HOPE CREEK GENERATING STATION
DOCKET NO. 50-354
DRAFT SAFETY EVALUATION REPORT
OPEN ITEM STATUS

Enclosed for your review and approval (see Attachment 4) are the resolutions to the Draft SER open items, NRC questions and structural audit items listed in Attachment 3.

Public Service Electric and Gas Company hereby submits the enclosed responses to DSER open items, NRC Questions, Structural Audit items, and NRC requests for additional information for the Hope Creek Generating Station.

FIGURE 430.88-1

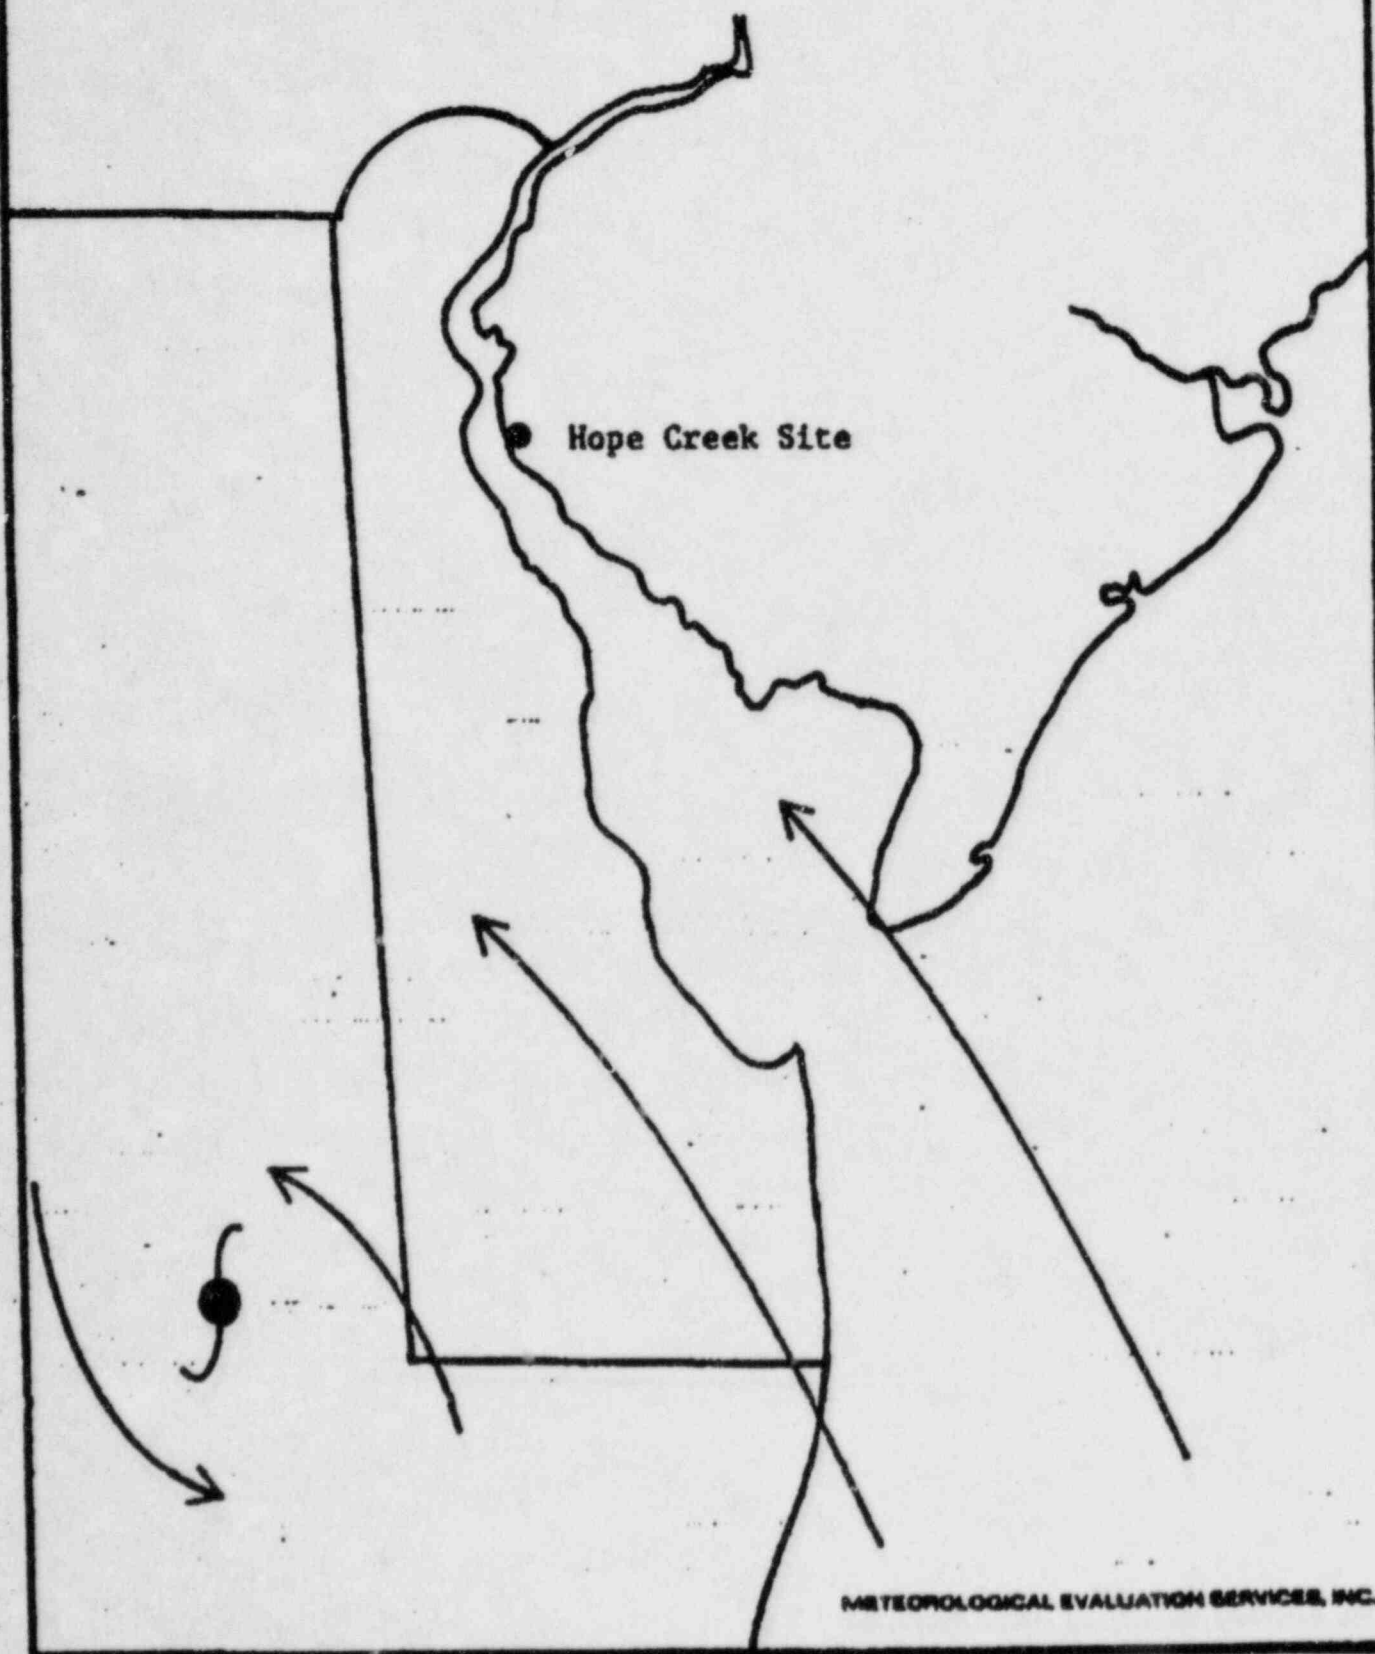
Provide additional justification to support your statement in Section 9.5.4.3 that sufficient additional fuel can be delivered to the plant site by truck, or barge. In your discussion include sources where diesel quality fuel oil is available and distances travelled from the source to the plant. Also discuss how fuel oil will be delivered onsite under extremely unfavorable environmental conditions. (SRP 9.5.4, Part I)

There are three key factors which support this conclusion. First, while any storm can remain stationary for an extended period, one in an adverse position (onshore) will lose its energy source and be eroded by surface friction. Secondly, any storm remaining offshore where it can retain all or some of its energy source will be in a position either to cause unusually low tides following the initial surge, or at least to provide shelter from the maximum winds because of the long fetch over the lower Jersey peninsula. Thirdly, the storm surge capable of seriously flooding the area is an enormous wave and it will not maintain site area flooding condition for prolonged periods (24-36 hours) even if the driving force continues.

A. Hurricane stationary in the least favorable position (see Figure 430.88-1)

FIGURE 1
IDEALIZED FREE-FIELD SOIL COLUMN FOR DECONVOLUTION
(POWER BLOCK AREA NORTH-SOUTH DIRECTION)

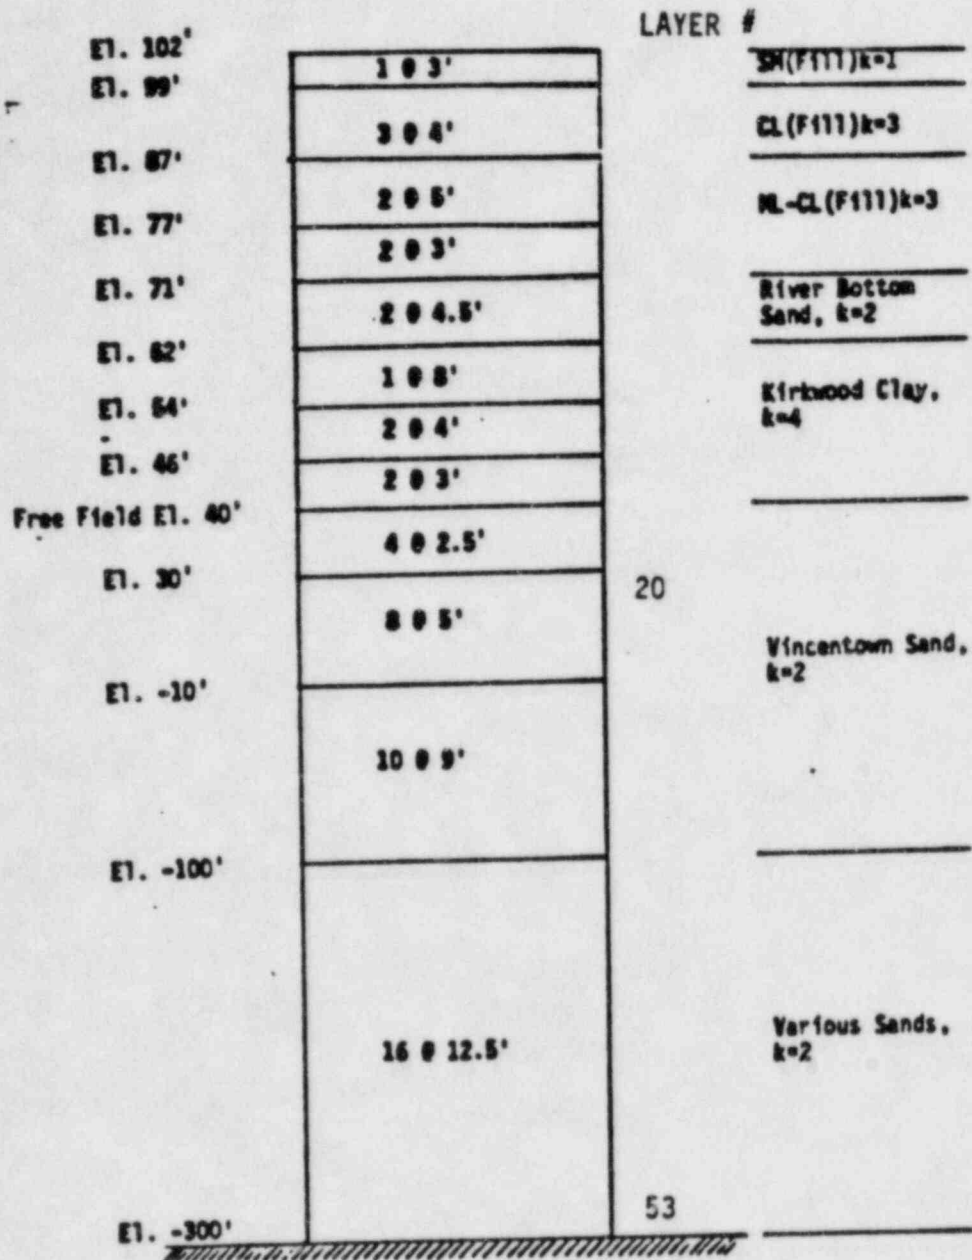
Provide tabulation of shear moduli used for the design basis model under Reactor Building Unit 2*. In addition provide values of shear moduli at low strain levels for both average and lower bound soil properties.

RESPONSE: The attached Figure 1 shows a typical soil column used for the deconvolution analysis. The attached Figure 2 shows a schematic representation of the soil model used for the soil-structure interaction analyses.

FIGURE 1
LOAD/SETTLEMENT PLOT FOR MARKER NO. 3

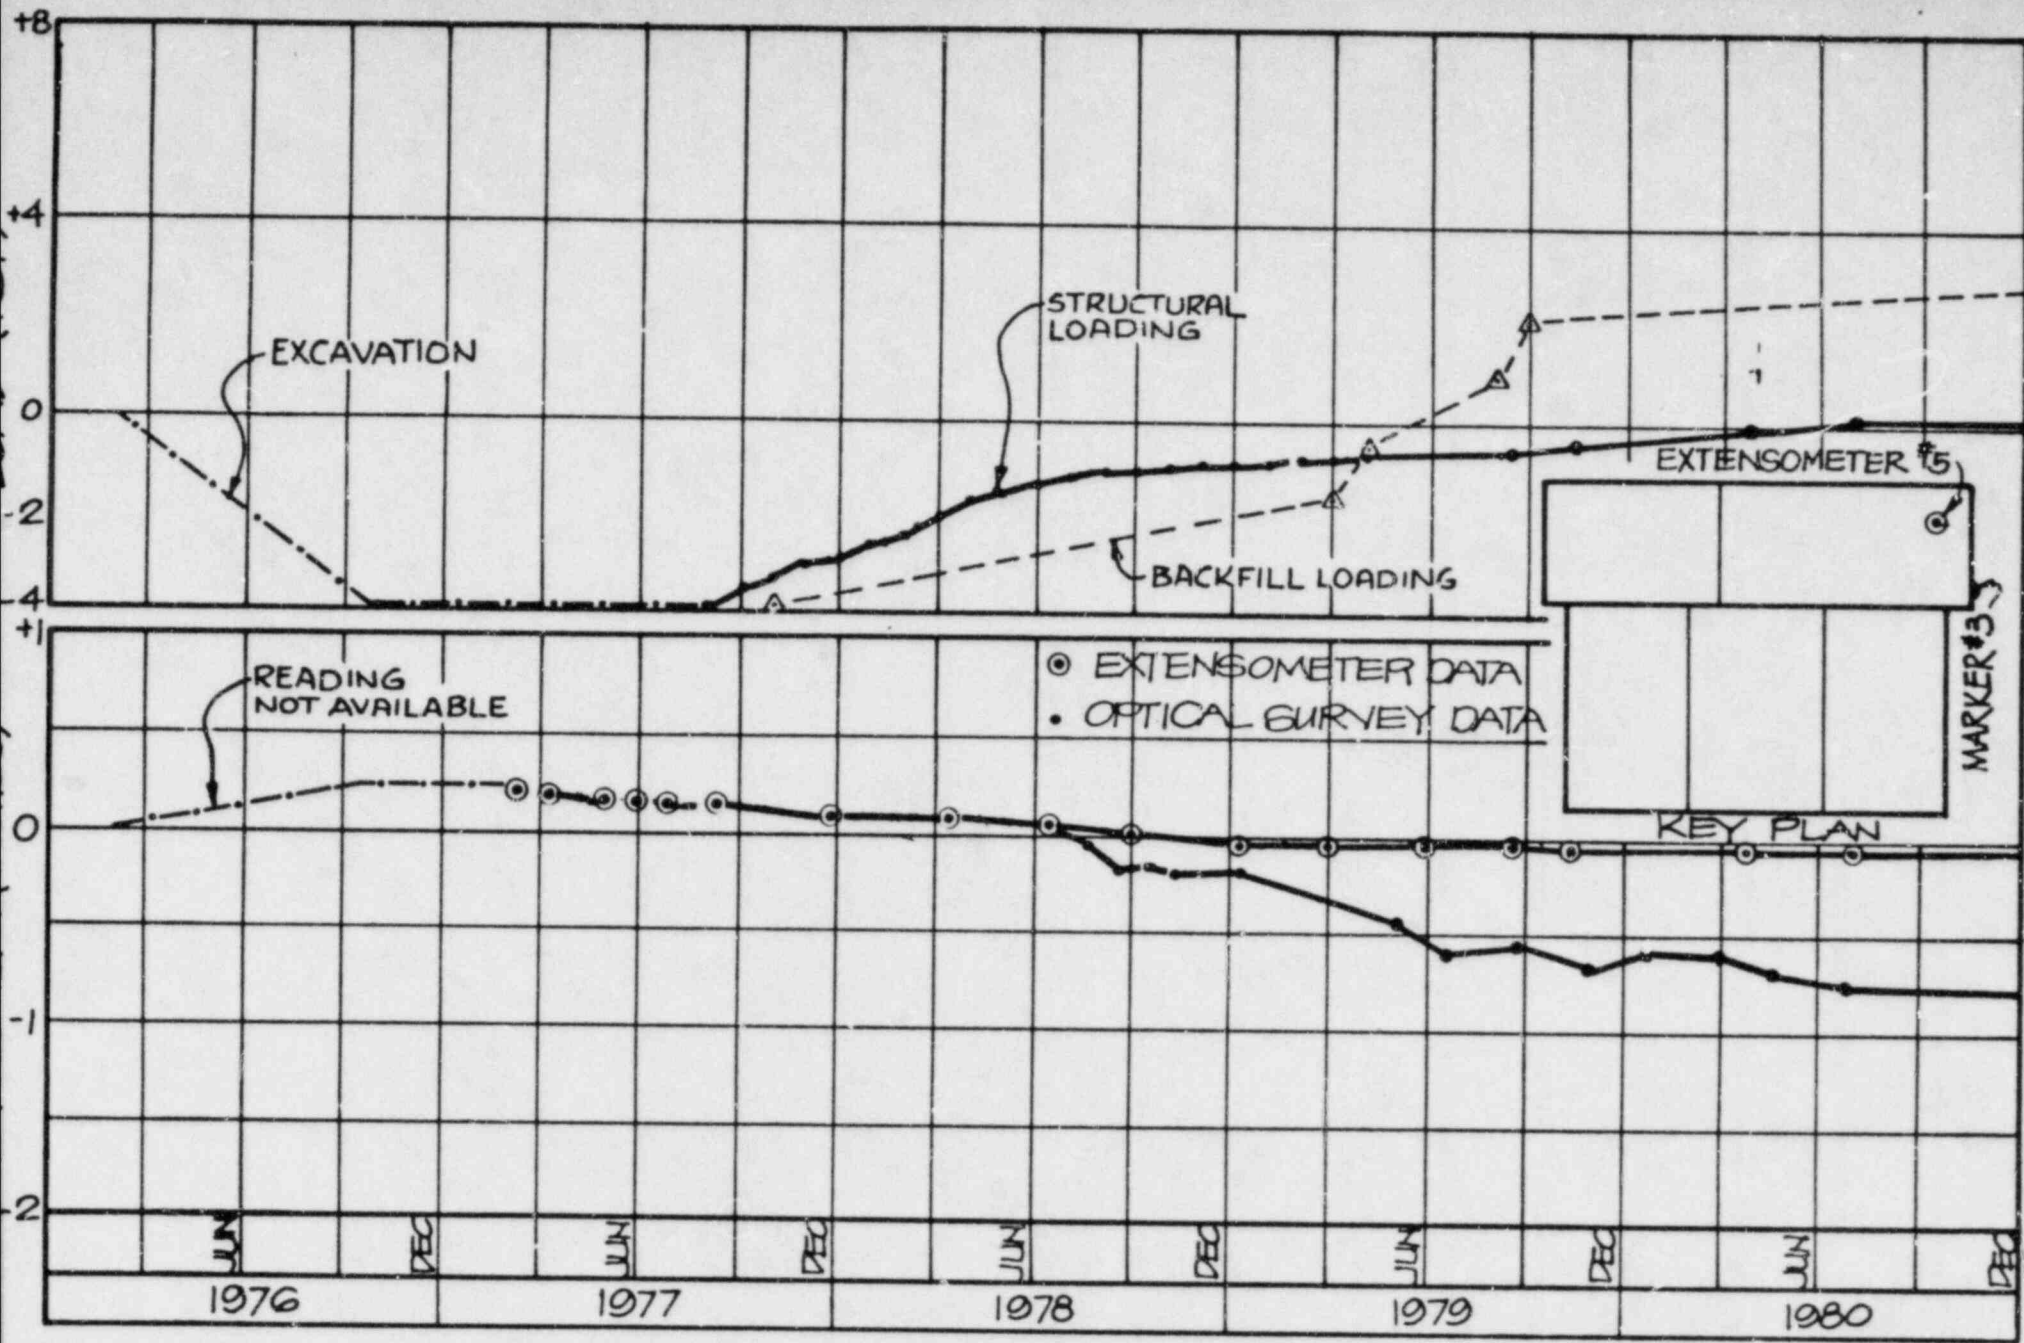
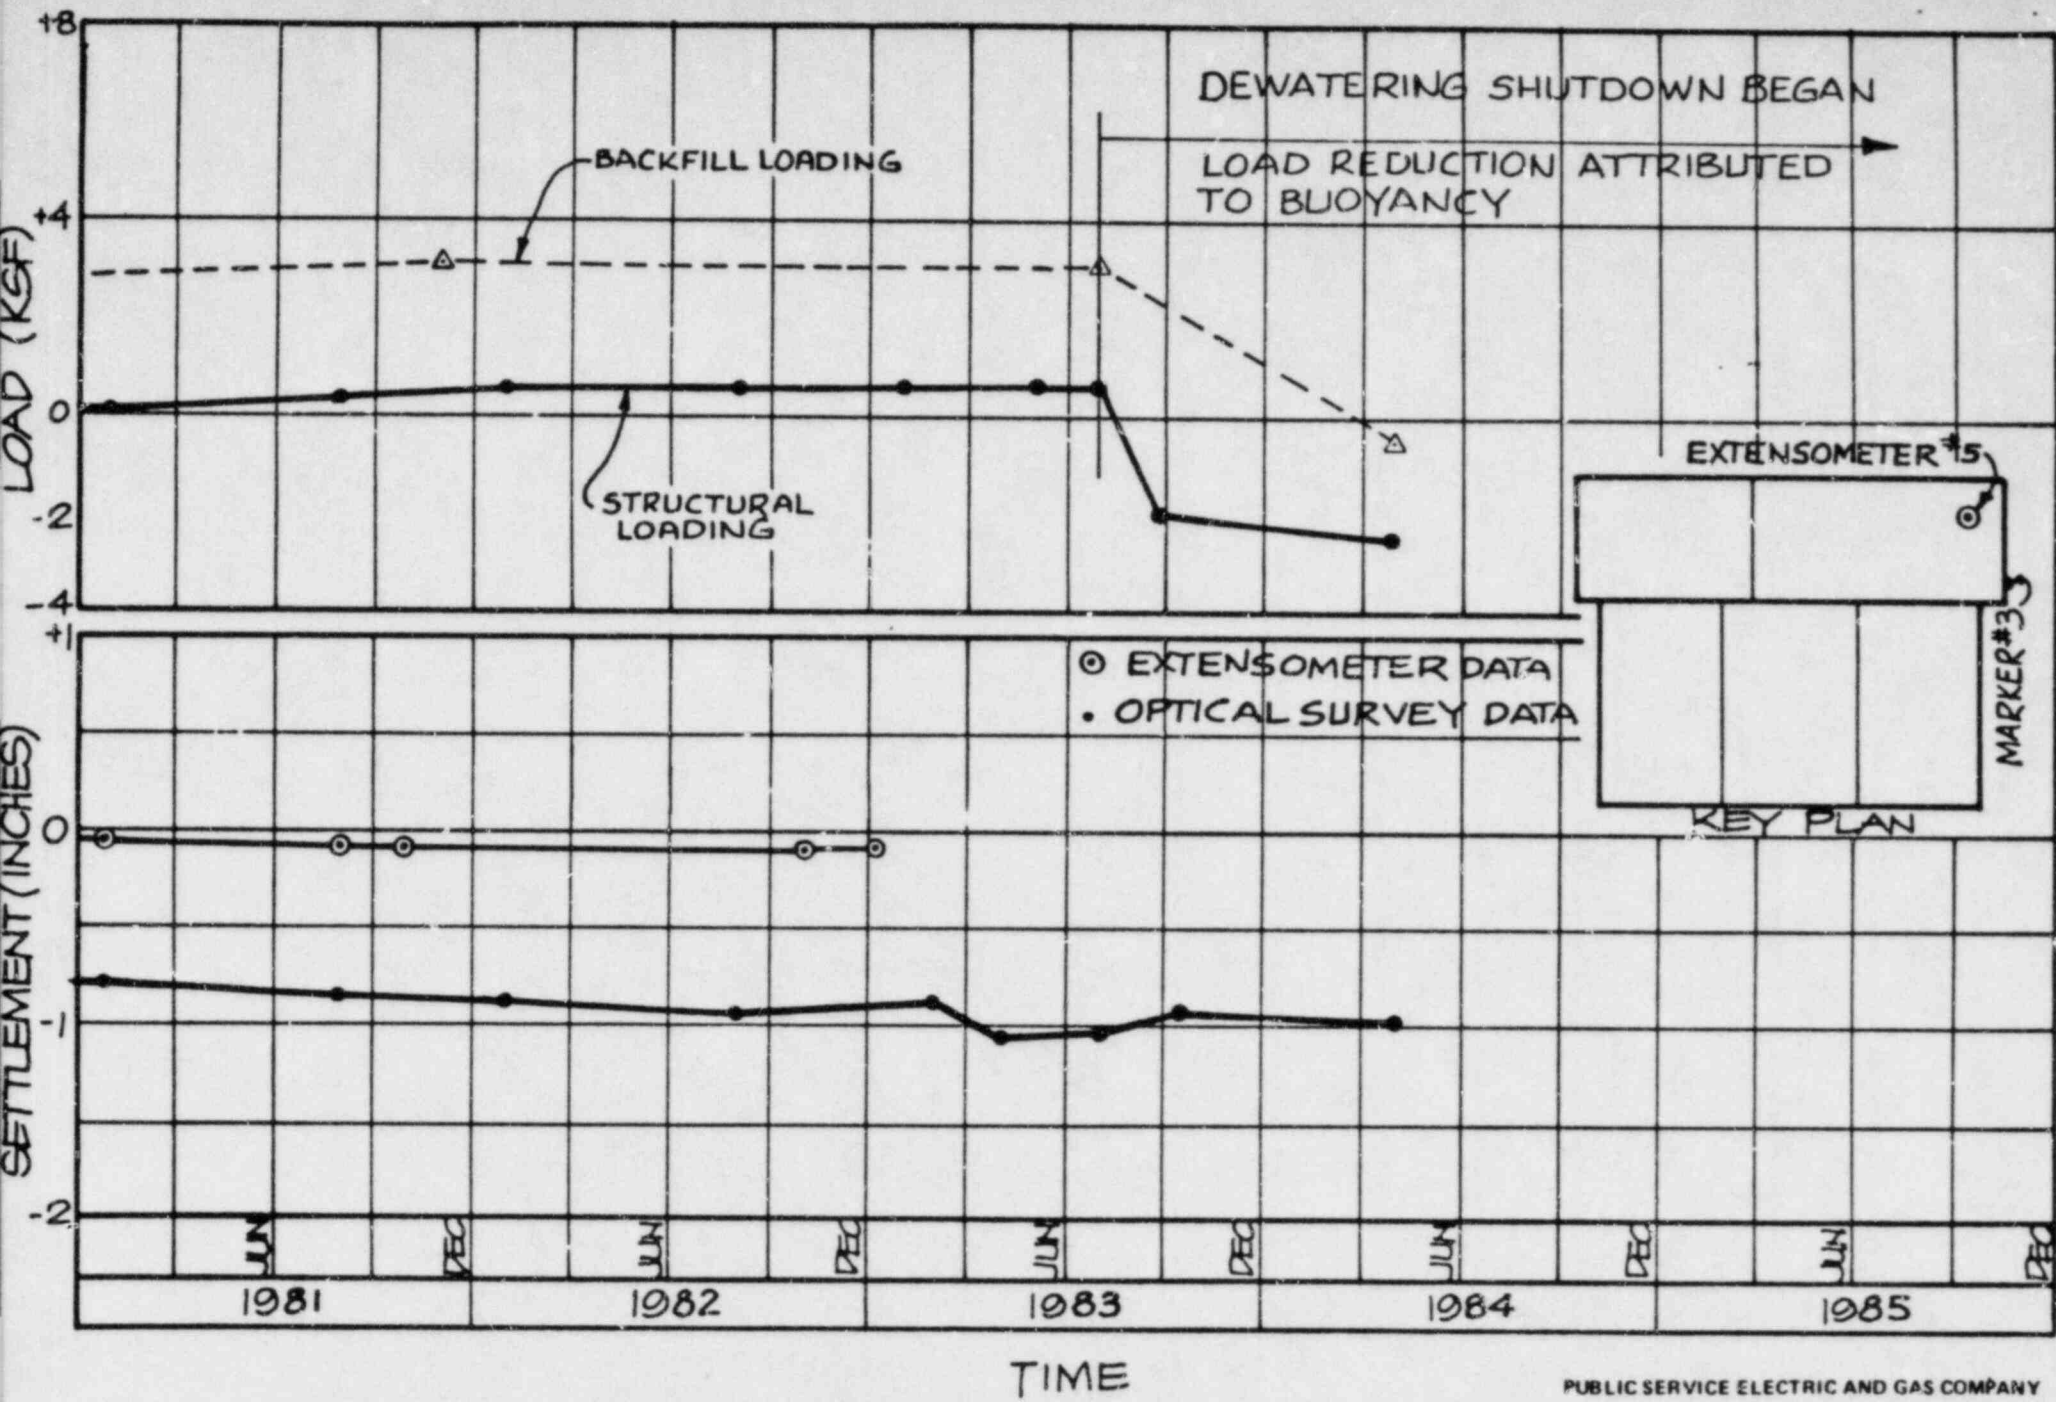
In justification of the statement ^{are} that the settlements measured at marker Nos. 16, 18 and 19, ~~and~~ due to the surrounding backfill loads, given in response to FSAR Question No. 241.25, revise the settlement plots for marker Nos. 3, 5, 16 and 18, as follows:

- o Add the loading history due to backfilling operation
- o Show the effect of decommissioning the dewatering system

The load/settlement plots for markers Nos. 3, 5, 16 and 18, have been revised to include effects of the backfilling and decommissioning of the dewatering system. The revised plots are attached in Figures 1 to 4.
